Hydraulic Modelling Addendum

Title **Hydraulic Modelling Addendum**

Job Name Peartree Hill Solar Farm

1.1.1 This Technical Note discusses additional work carried out to support proposed Solar PV development at Peartree Hill following the Environment Agency (EA) review of the development proposals and hydraulic modelling. It forms an addendum to the Peartree Hill Solar Farm Hydraulic Modelling Report 20-206-60-050.

Figure 3-1 Missing Structures

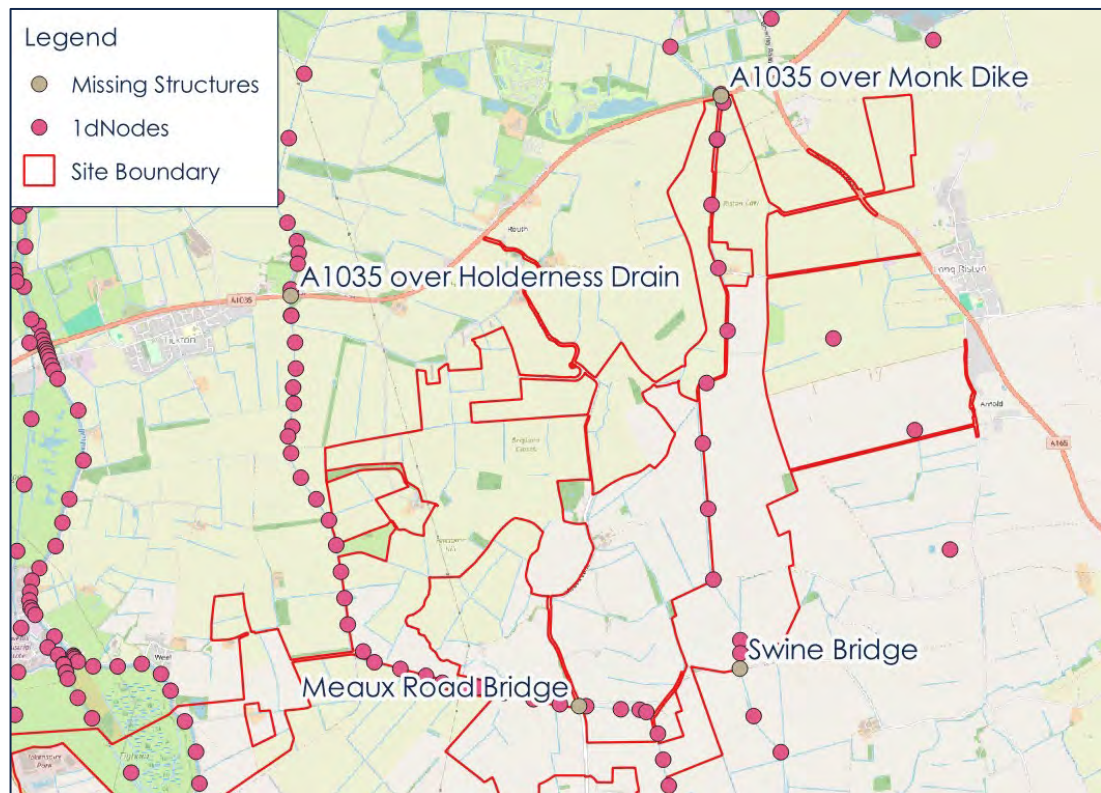
- 3.1.1 The EA model review notes a number of missing structure in vicinity of the site as listed below and shown in Figure 3-1:
- A1035 bridge over Monk Dike (FM cross section Cat00000)
 - A1035 bridge over Holderness Drain (FM cross section HN43),
 - Swine Road Bridge over Monk Dike (closest FM cross section MK4055), and
 - Meaux Road Bridge over Holderness Drain (FM cross section HN21).

- 3.1.2 Three of these structures have been added to the model using available data and where information was sparse a conservative approach to the structure definition was taken. The structure at HN21 as it appears to be a clear span structure with the deck approximately 3m above the maximum water level. Structure details definitions are appended to this document.

3.1.3 The model was reran with the design event flood. The maximum flood level was compared with the existing baseline design event outputs and the results are shown in Drawing 20-206-60-255-00 & 20-206-60-256-00.

3.1.4 Flood levels are generally within +/-20mm within the site boundary, the exception being a small part of parcel B1 where levels are reduced by 60mm and land west of parcel F12 where levels are reduced by 180mm. The only significant increase within the site are the parcels to the east of the Monk Dike (B2-4, B8 & C1-C3) where levels increase by 20mm. The change in outline is insignificant.

20-206-60-253-00 Monk Dike Defence Removal West – 1 in 100yr +17% Depths

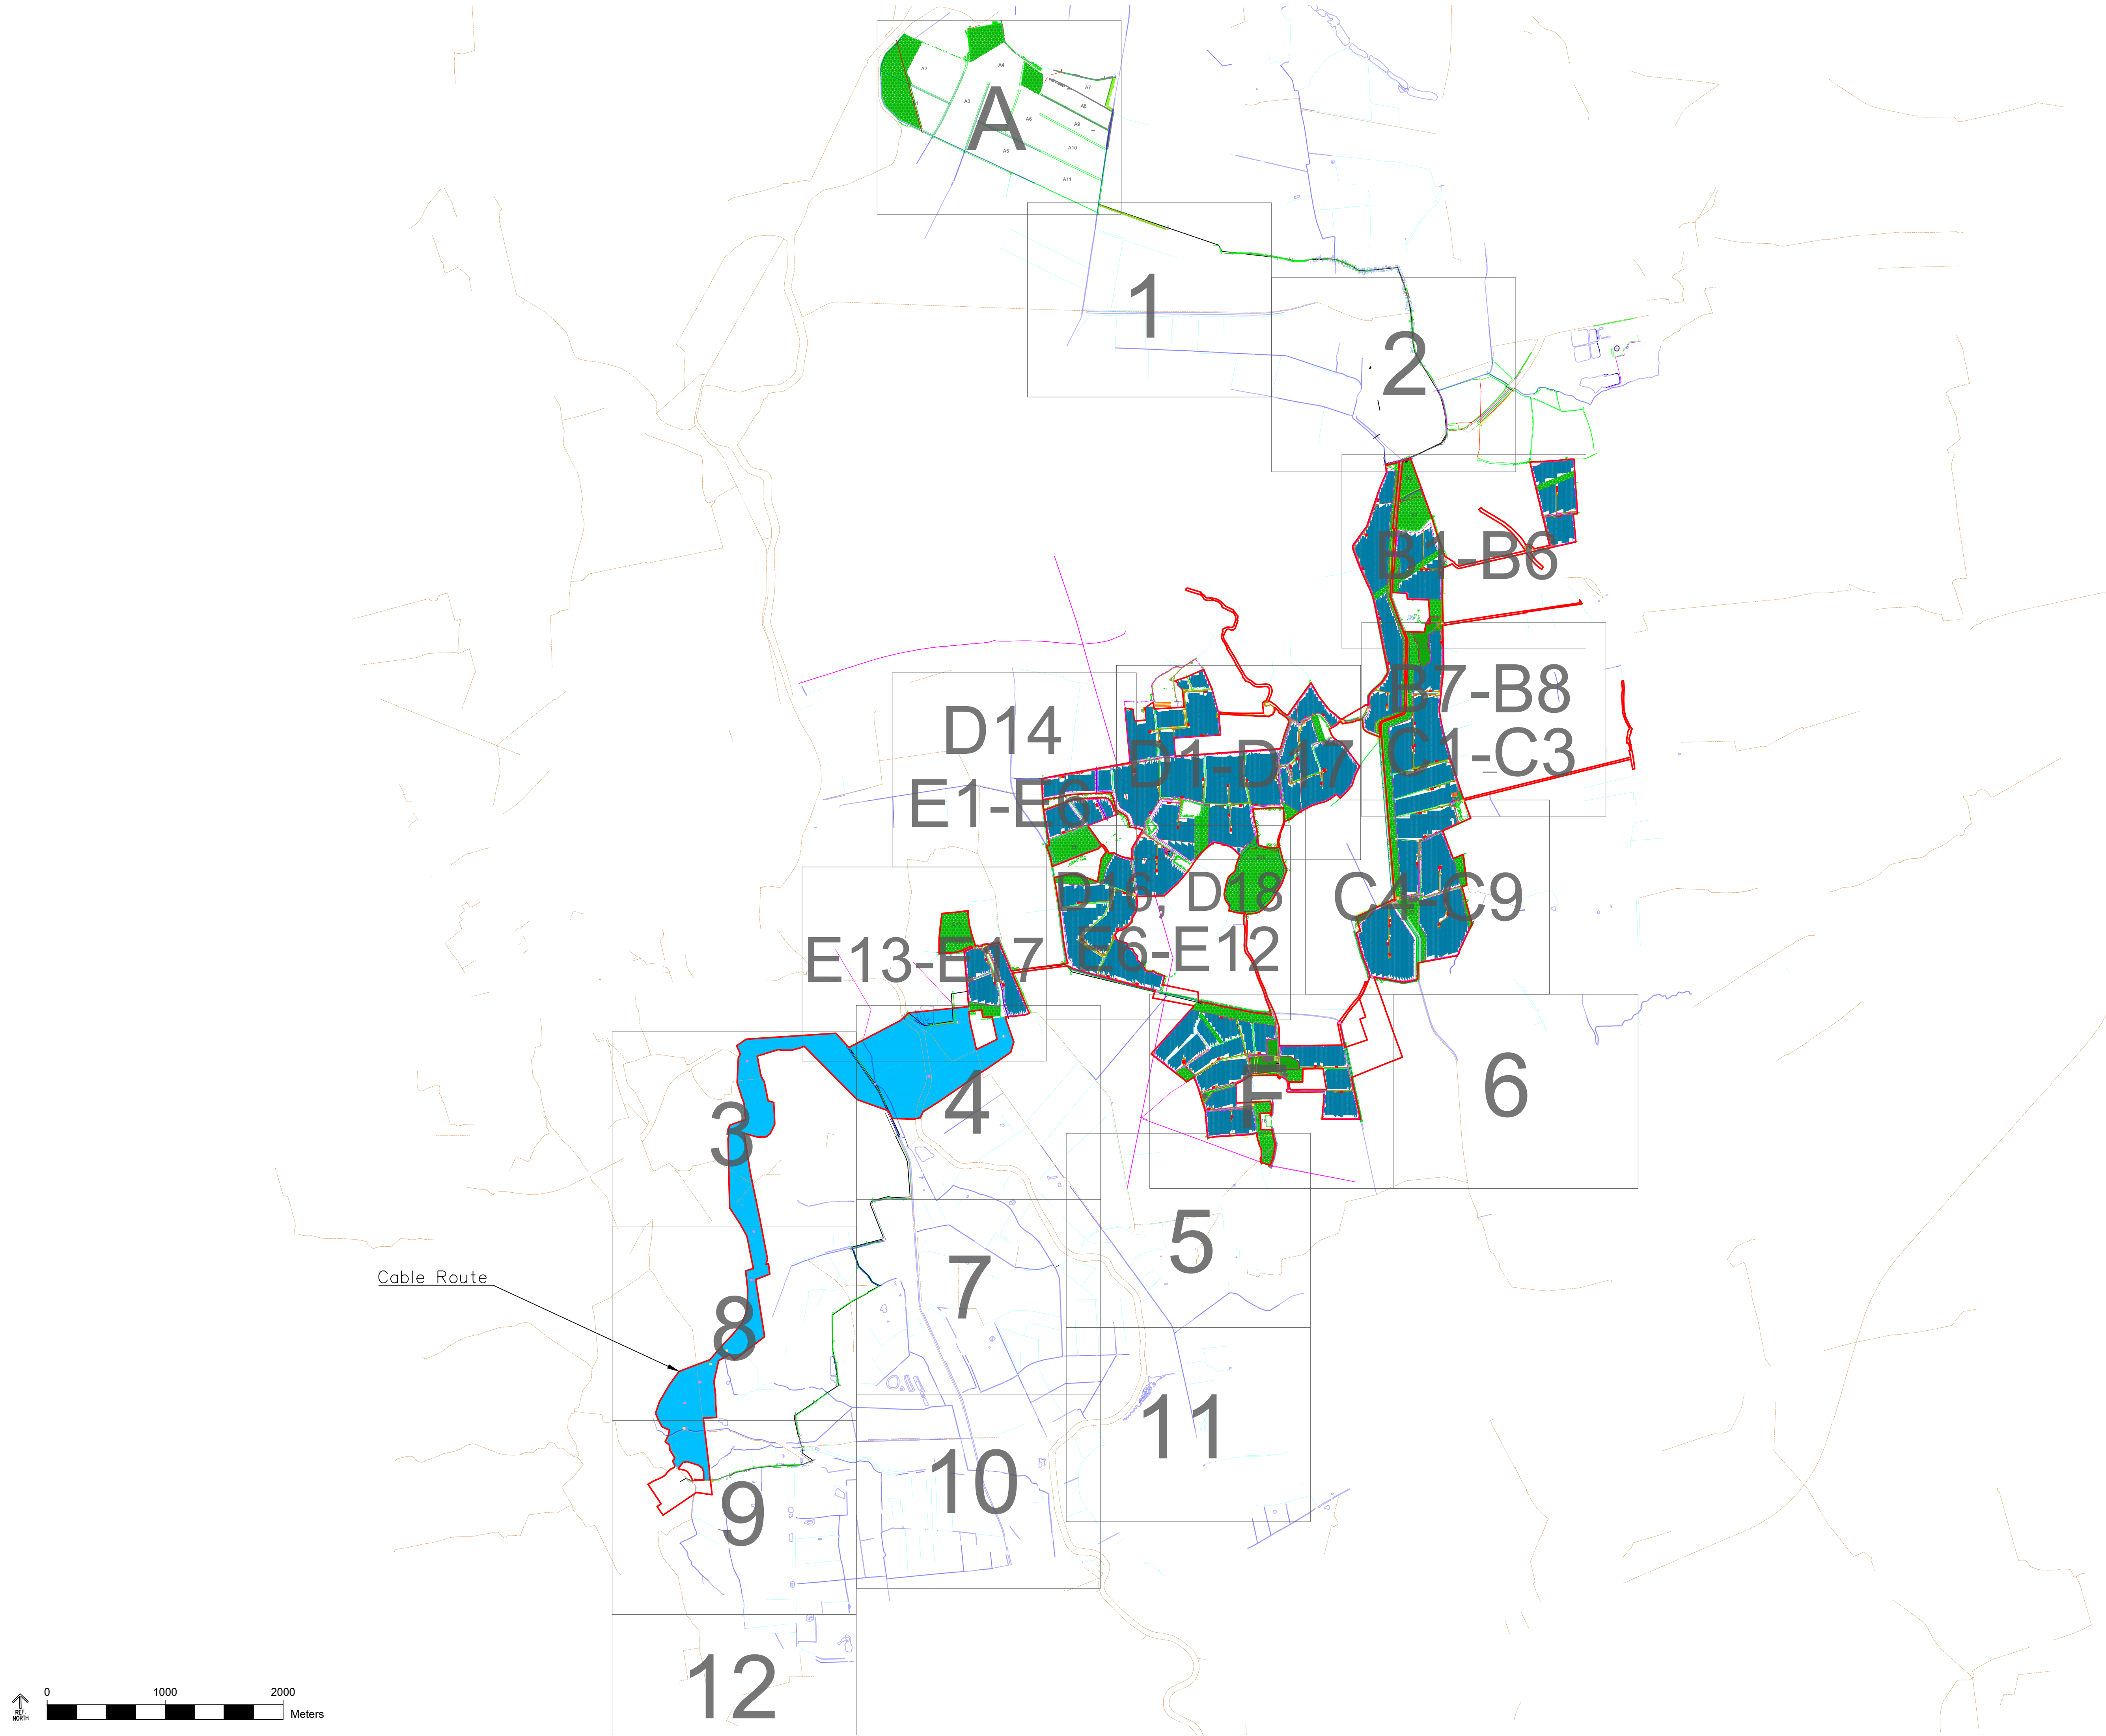
2.1.1 The Environment Agency letter dated 25th June 2024 (ref:XA/2024/100093/01-L01) states:

“Although breach modelling is being undertaken by the applicant, any assessment of residual flood risk, both now and in the future, will be insufficient without further consideration of the condition of the flood defences. Through understanding the condition of existing defences and how defence conditions may change over the lifetime of the development, you must give appropriate consideration to how residual flood risk can be managed and mitigated.”

- 2.2.15 The results of this simulation for the future 1 in 100 year flood is presented in Drawing 20-206-60-253-00 appended to this note. The drawing shows that the extent of flooding on the site only marginally exceeds the maximum breach extent. A review of modelled depths reveals that the flooding is not increased significantly when compared to the combined worst-case from the breach scenarios for the vast majority of the site. The exception being in Parcels B1 & B7 where flood levels are typically 0.1m higher.

- 2.2.18 The results of this simulation for the future 1 in 100 year flood is presented in Drawing 20-206-60-253-00 appended to this note. The extent of flooding adjacent to the section of defence removed is almost identical to the worst-case breach scenario and flood levels are just 5mm higher.

Flow Sensitivity
Sheet 1 of 2

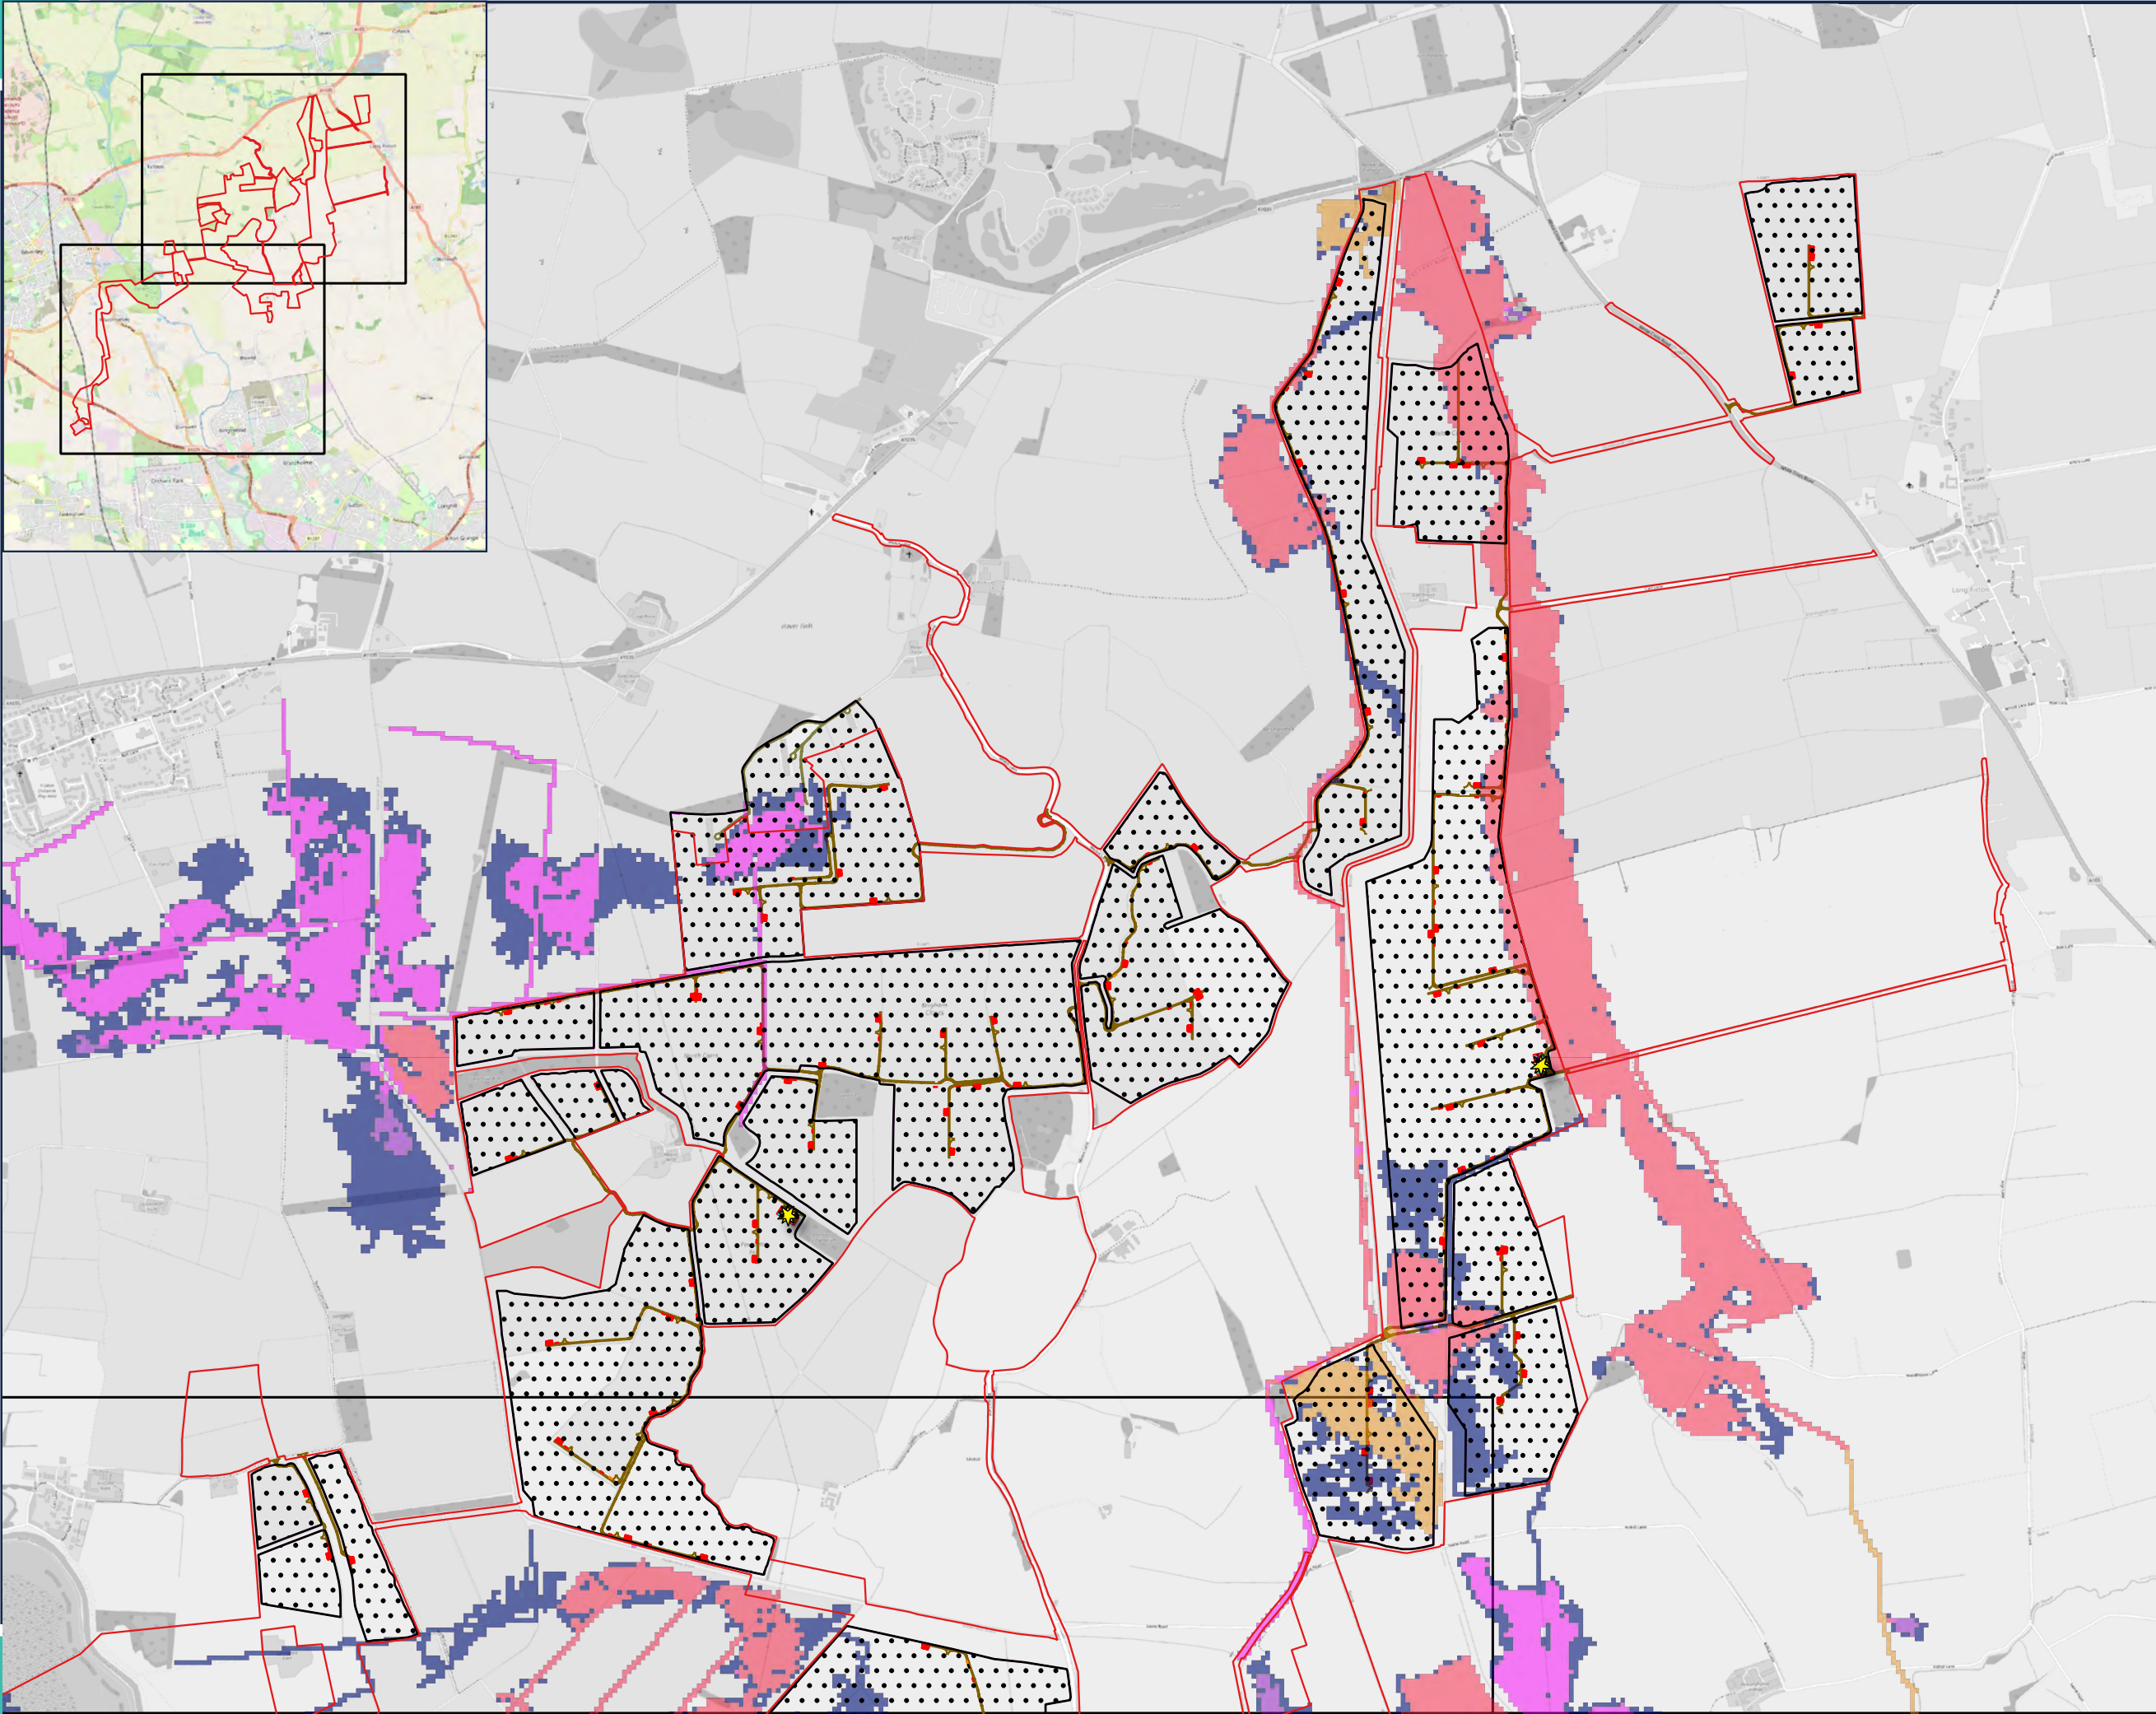
4.1.1 The EA letter pertaining to the review of the hydraulic modelling (ref: XA/2024/100110/01-L01) includes the following query.

“There are some areas of additional flooding in the baseflow/SPR sensitivity test within the development area. Is sensitive infrastructure located outside of these areas?”

4.1.2 There is no sensitive infrastructure in these areas. Solar panels will be in these areas but will be raised significantly above the predicted flood levels. A revised version of the flow sensitivity drawings which includes containerised infrastructure and substation locations is appended to this note.
